E Line Recommended Plan

Linden Hills Neighborhood Council

March 1, 2022

Upton & 43rd Street Recommended Corridor Plan

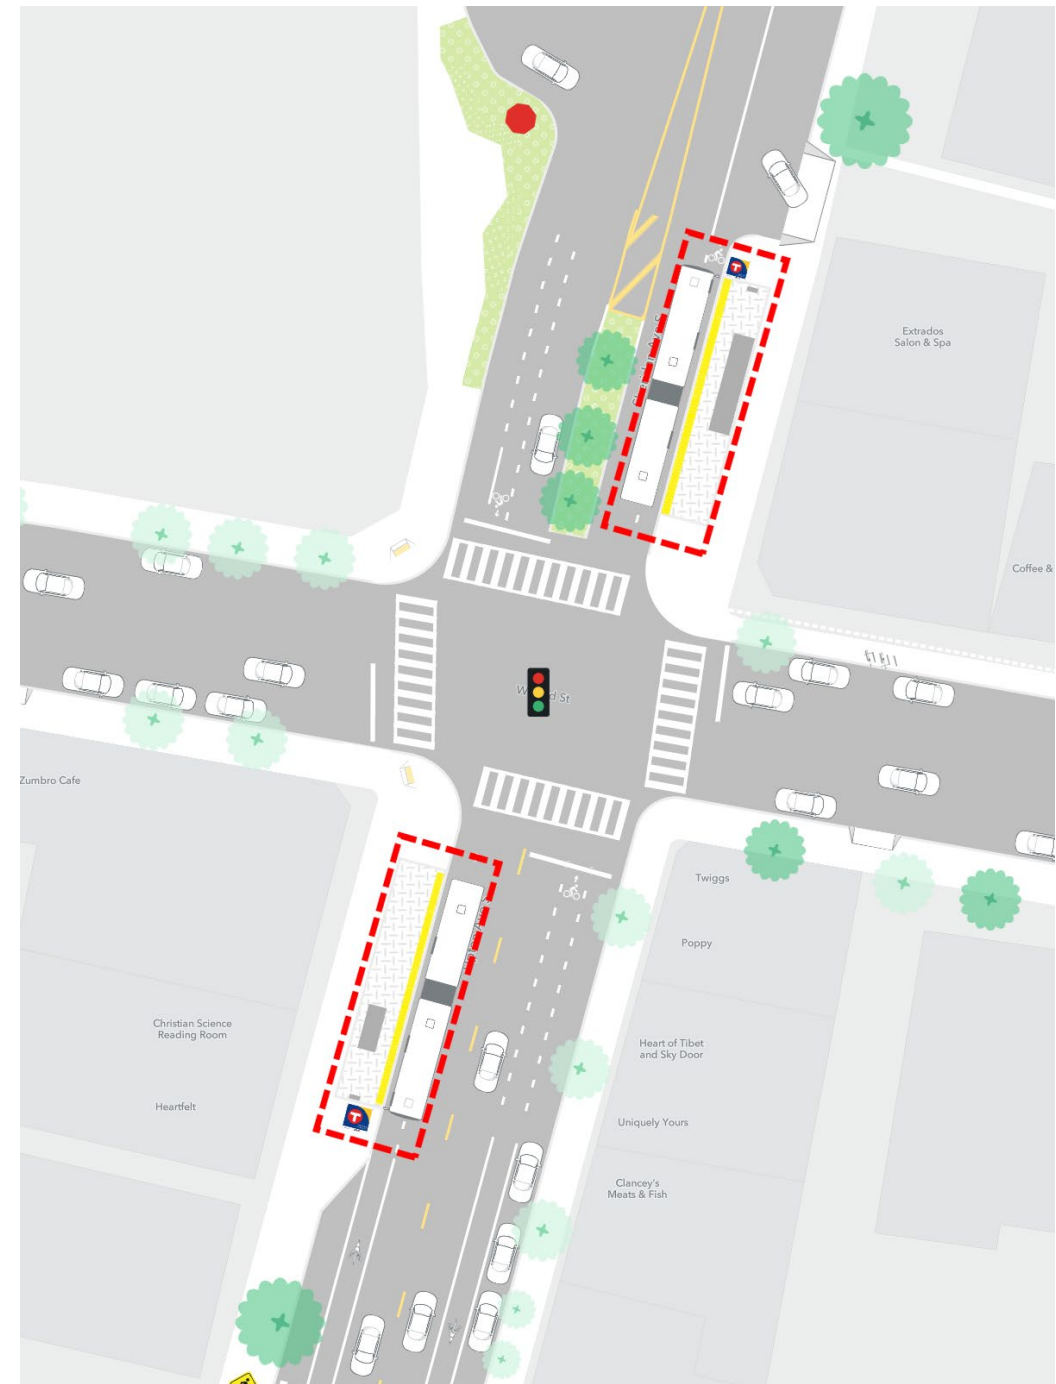
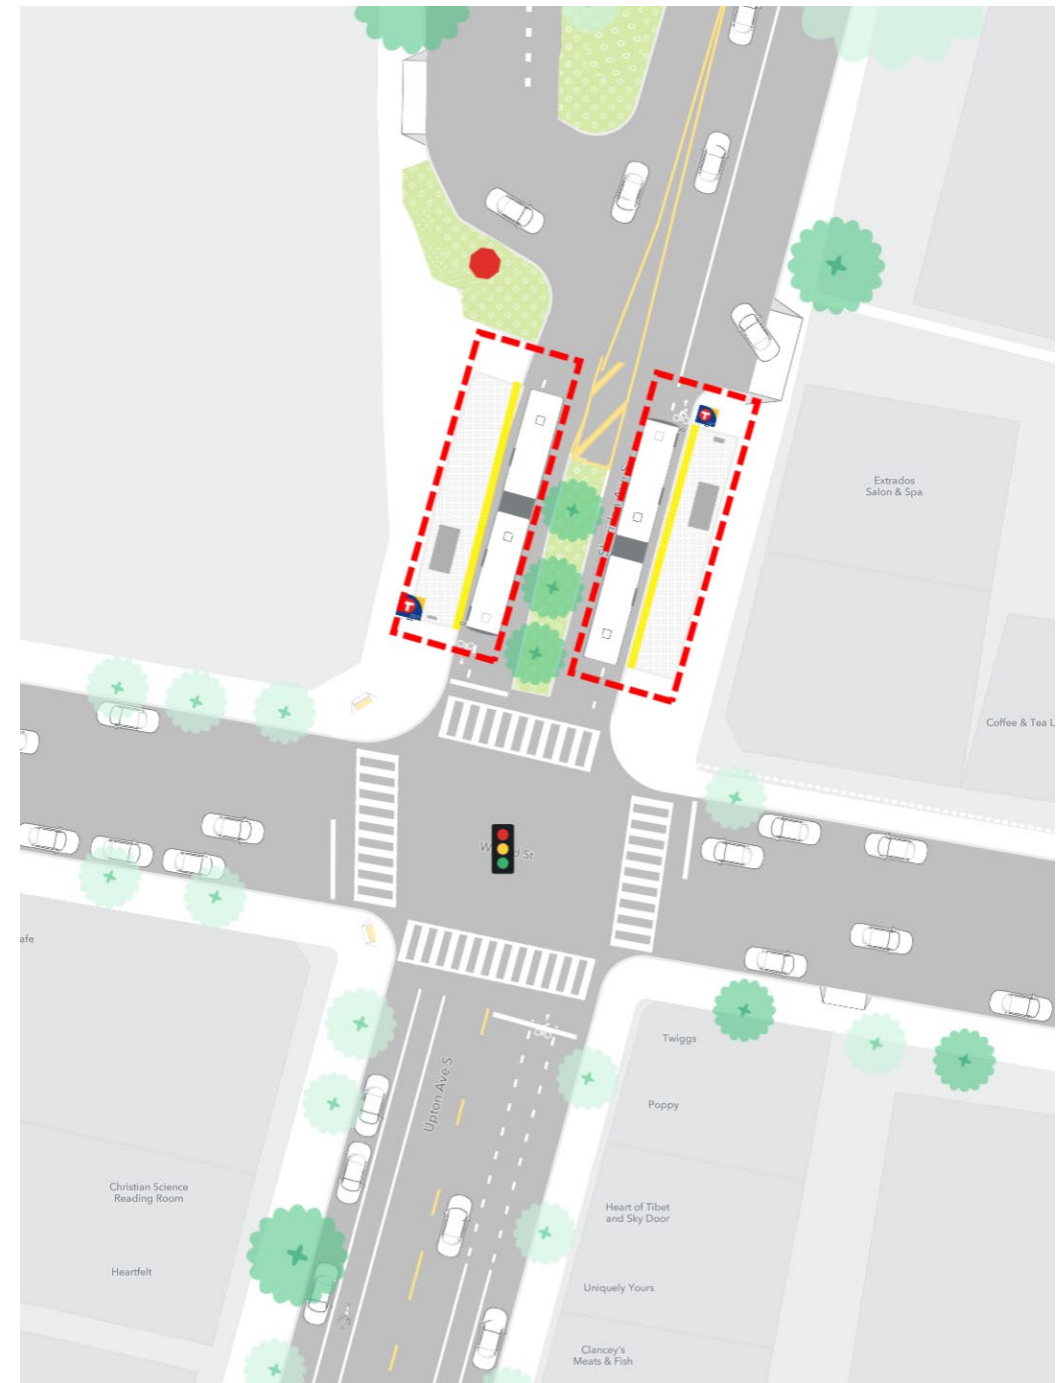
- Additional alternatives analyzed based on draft plan feedback
- Shift southbound platform from farside (southwest) corner to nearside (northwest) corner
- No change recommended to northbound platform

Additional southbound alternatives analyzed

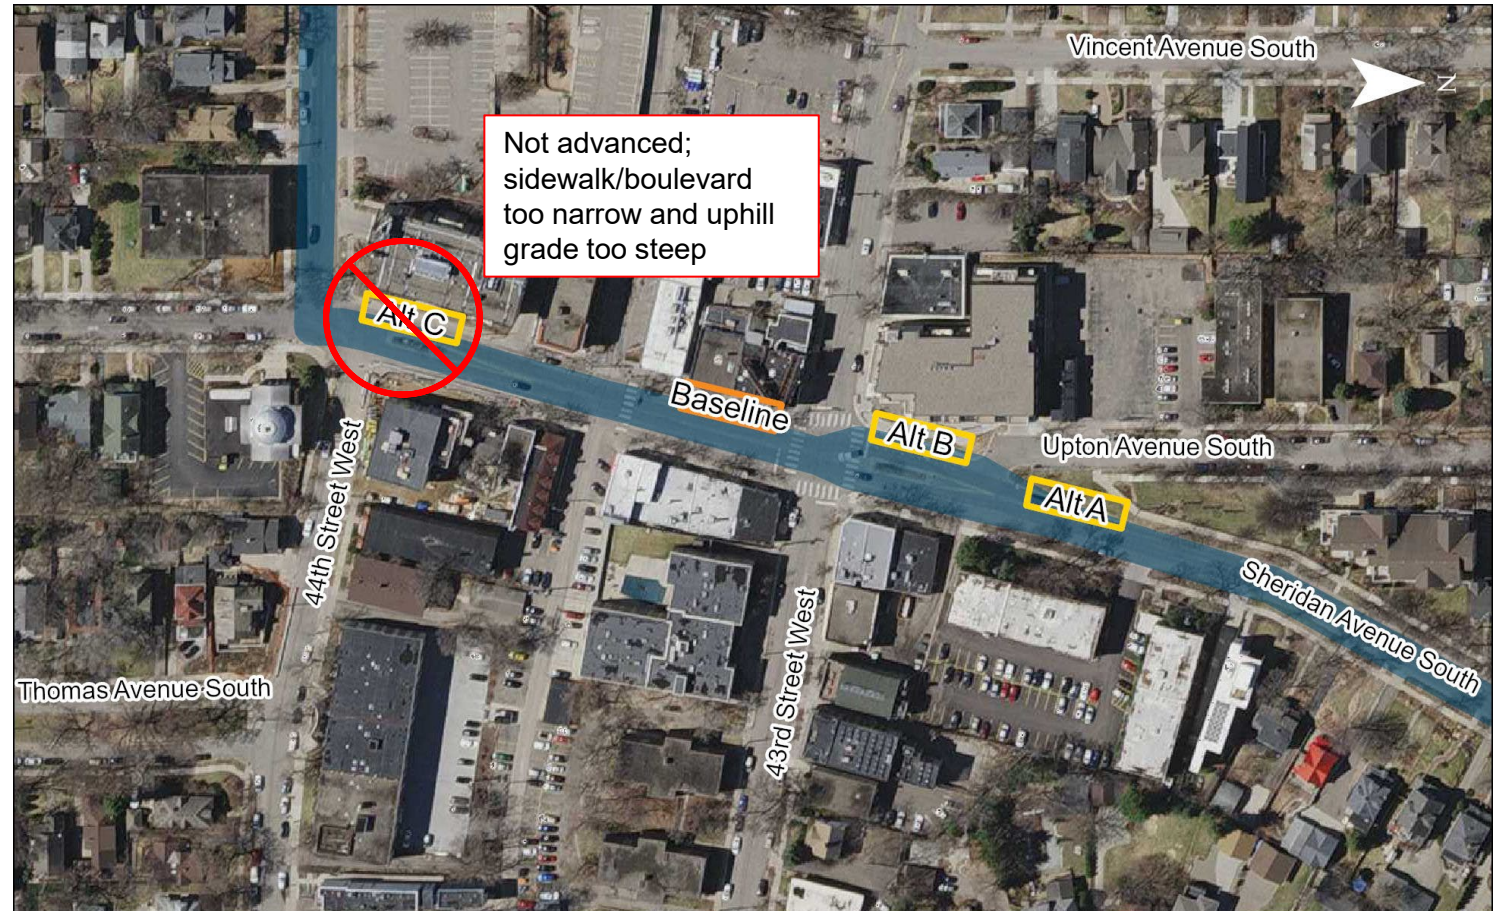
- **Baseline Location:** Upton Ave and 43rd St farside
- **Alternative A:** Sheridan Ave and 43rd/42nd St midblock
- **Alternative B:** Upton Ave and 43rd St nearside
- **Alternative C:** Upton Ave and 44th St nearside
 - not advanced

Additional northbound alternatives analyzed

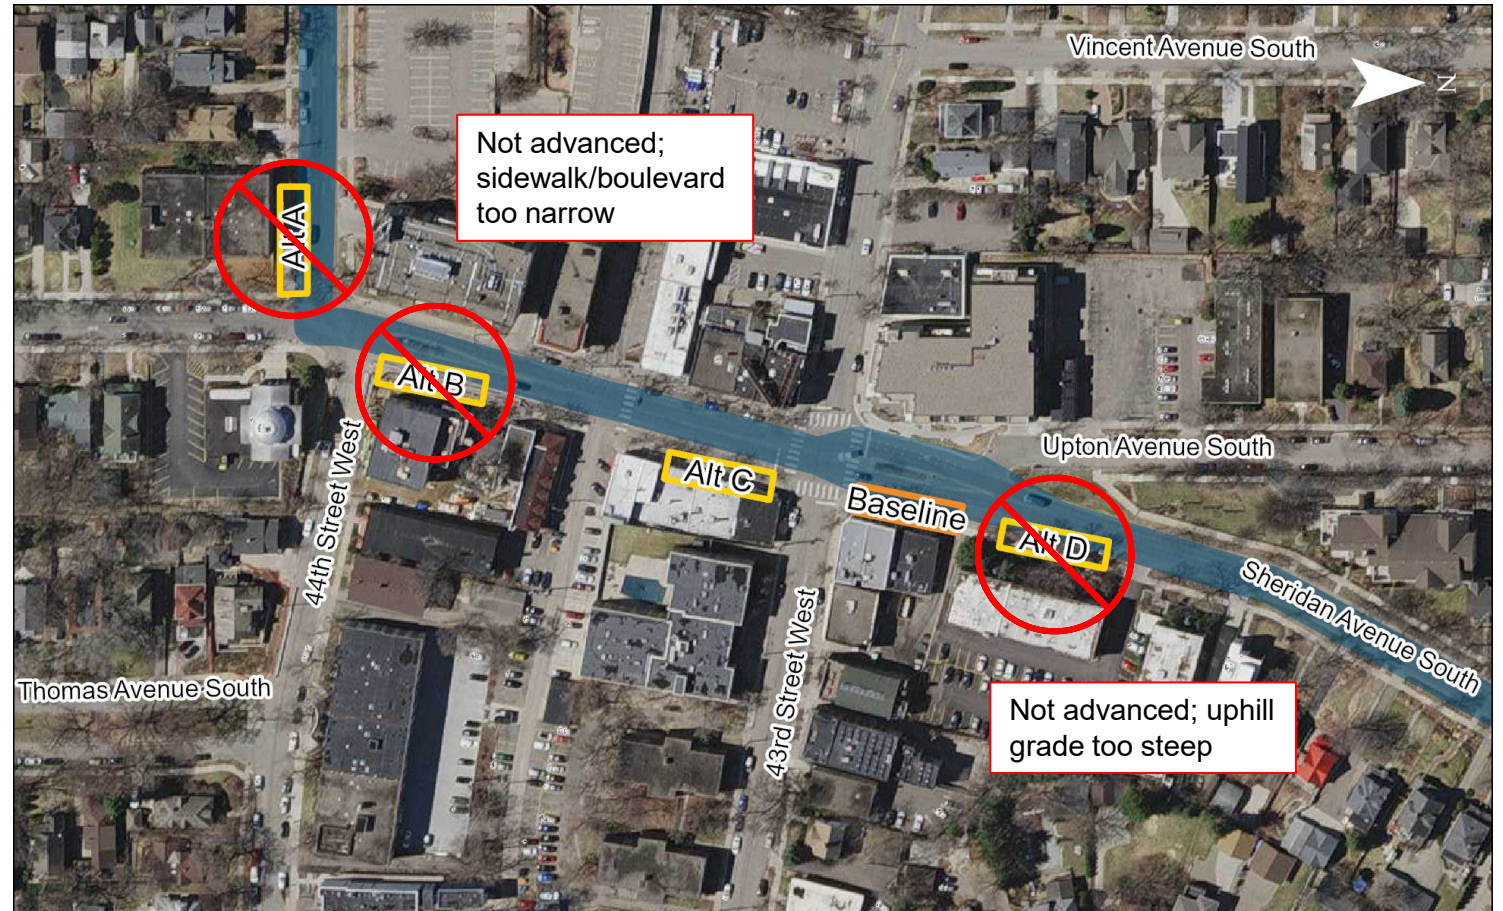
- **Baseline Location:** Upton Ave and 43rd Street farside
- **Alternative A:** 44th St and Upton Ave nearside
 - not advanced
- **Alternative B:** Upton Ave and 44th St farside
 - not advanced
- **Alternative C:** Upton Ave and 43rd St nearside
- **Alternative D:** Sheridan Ave and 43rd/42nd St midblock
 - not advanced

Changes to platform locations in recommended corridor plan

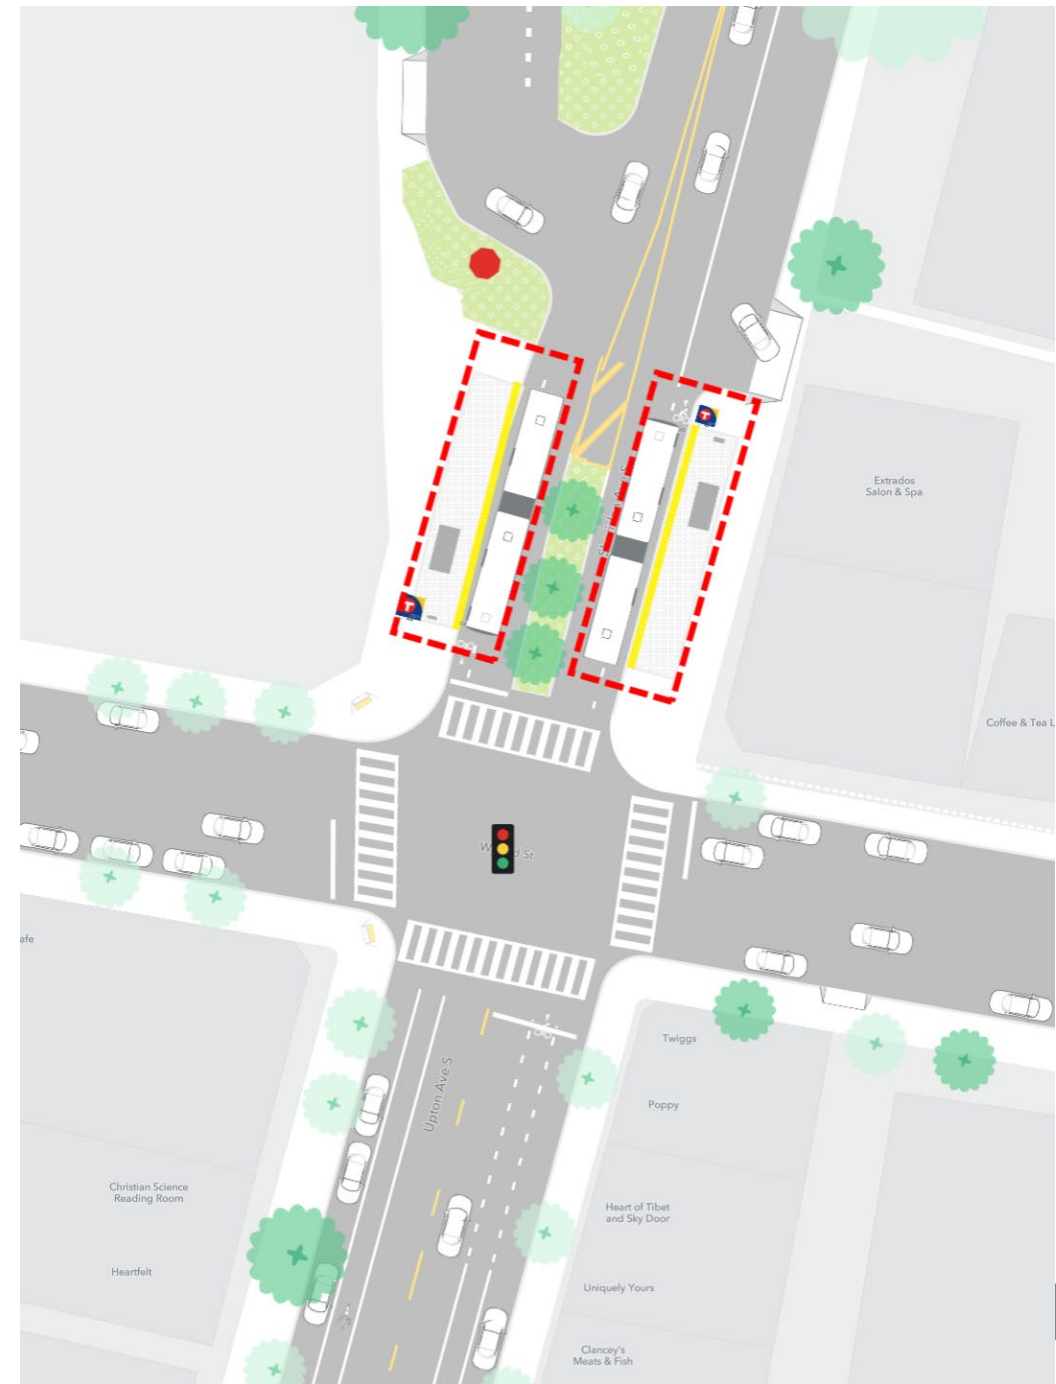
- Reduces reduction in on-street parking spaces from 7-8 spaces to 3 spaces
- Reduces potentially disturbed boulevard trees from 7-8 to 4 trees (station design will include preservation or replacement)
- Reduces potential effects on storefront visibility
- Maintains convenient access to commercial district

44th Street & Abbott (formerly Zenith) Recommended Corridor Plan

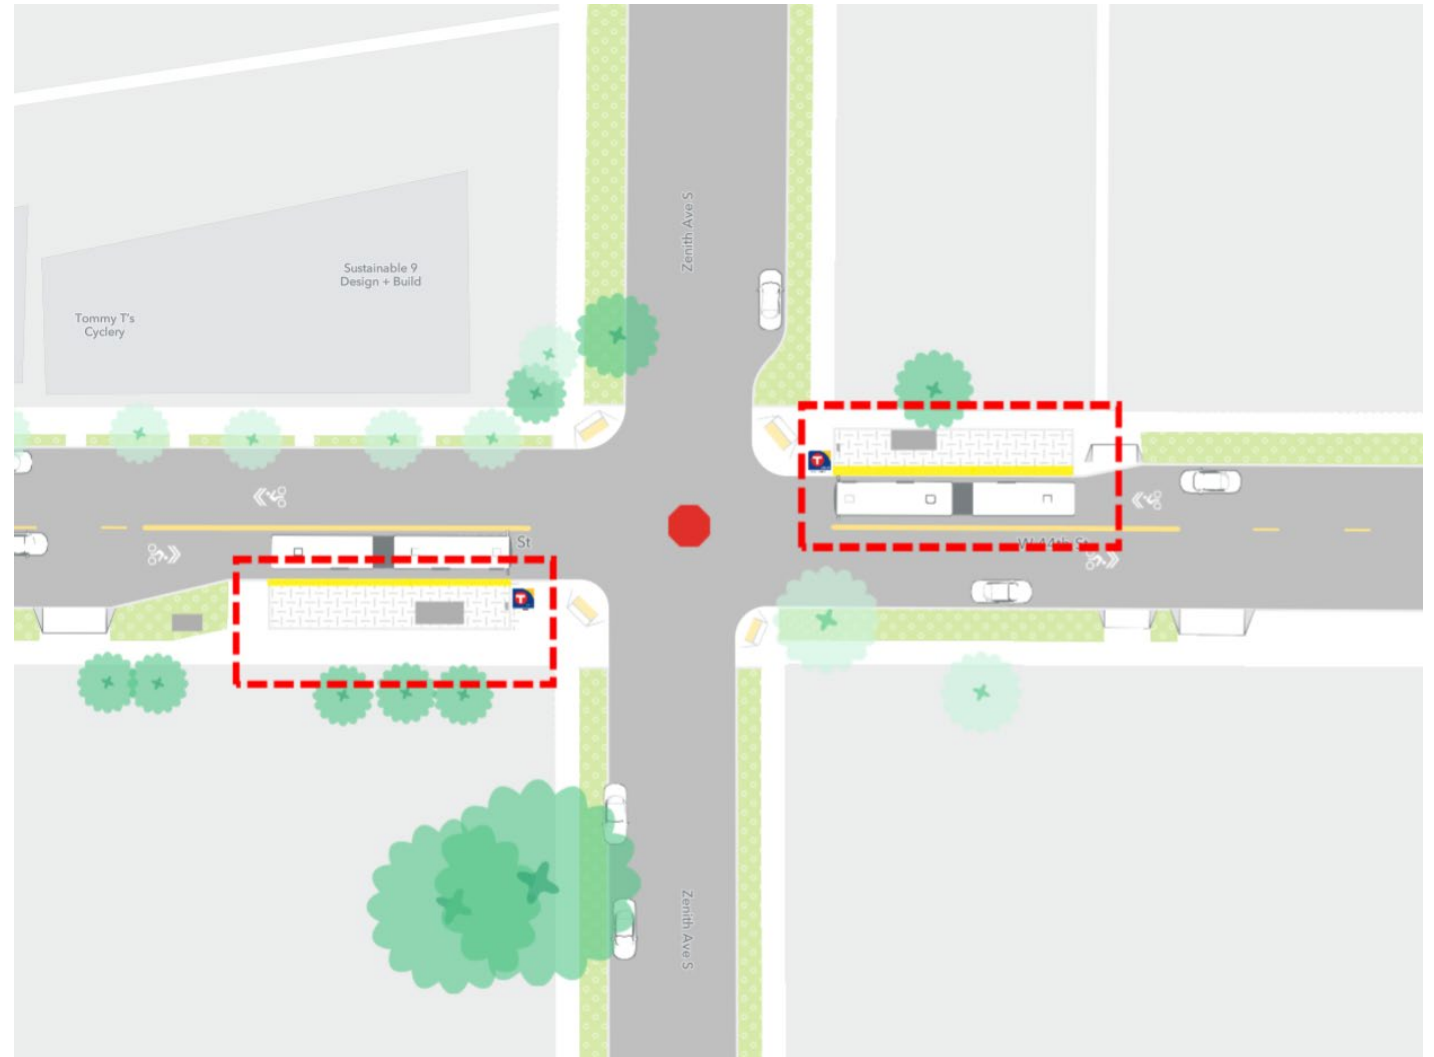
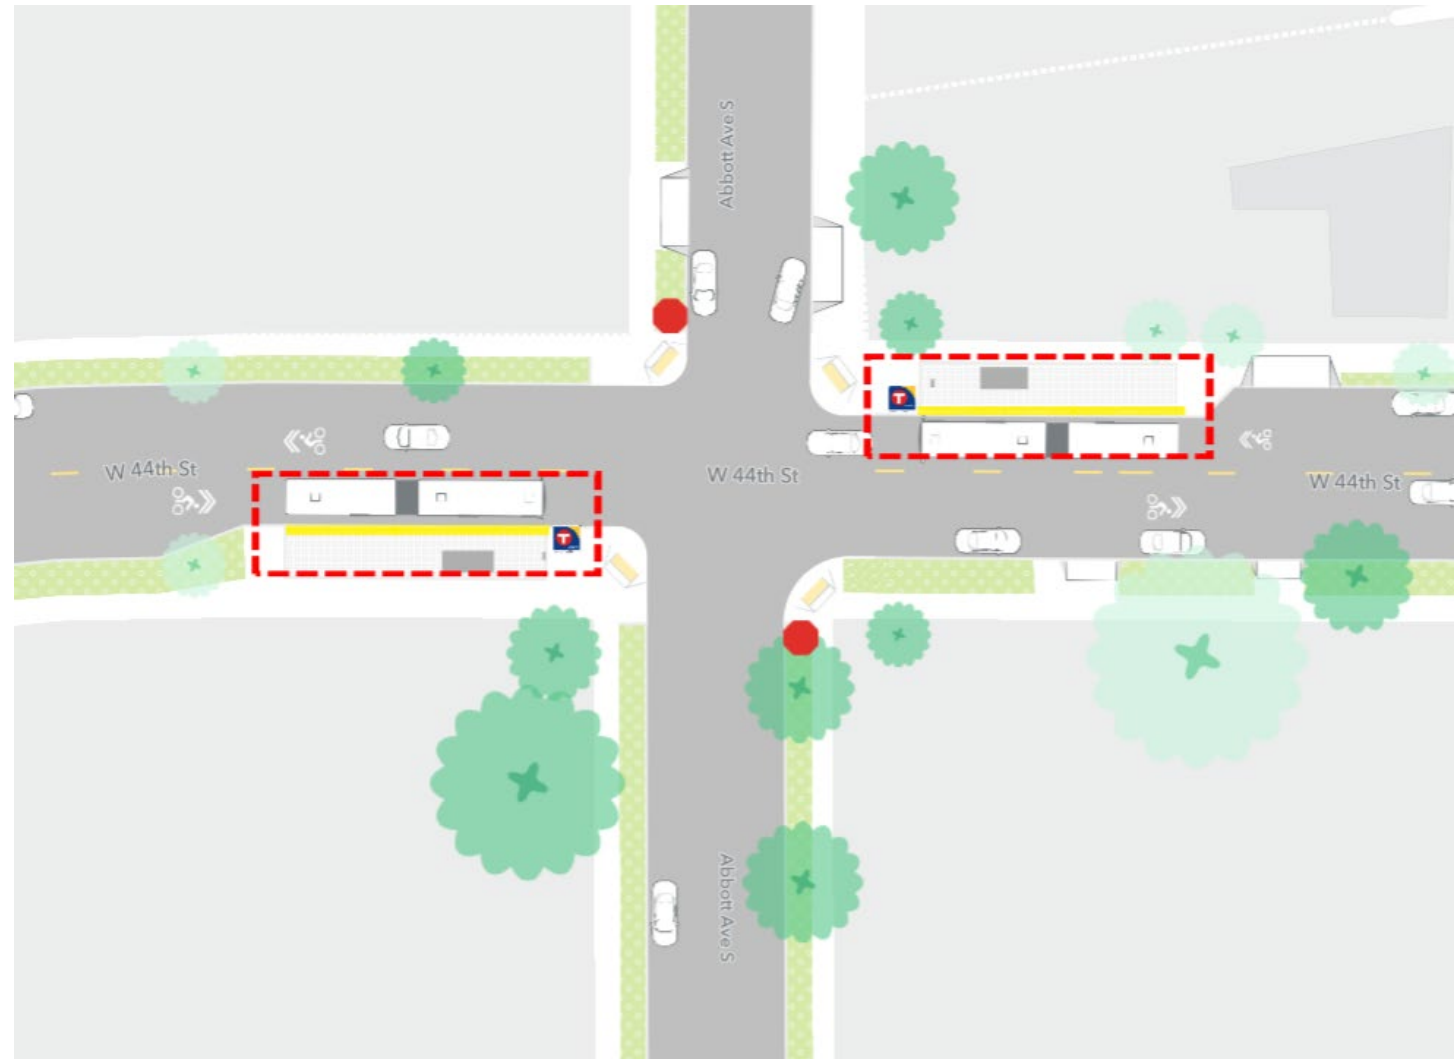
- Southbound platform proposed on nearside (northeast) corner of intersection
- Northbound platform proposed on nearside (southwest) corner of intersection
- Recommended change shift station location to 44th Street and Abbott Avenue

- Recommended shift from Zenith
 - Formal request from City of Minneapolis
 - New planned residential density at southwest corner of intersection
 - Closer to commercial area centered around Beard Avenue
- Southbound platform proposed on nearside (northeast) corner of intersection
- Northbound platform proposed on nearside (southwest) corner of intersection
